Fitzsimons Building – Phase 1 Roof Anchors & Fall Protection

Project Number – 22-122837

Wednesday, June 28, 2023 ADDENDUM 1

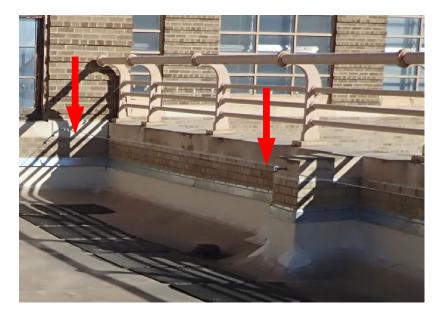
7. Please advise on the method of connection and material for the existing wire that is to be removed on the roof of floor 5.

Response: Existing wire appears to be 3/8" wire rope connected to structure with eye bolts. The wire, as well as the eye bolts shall be removed for the safety of future facade access workers. See photo below.
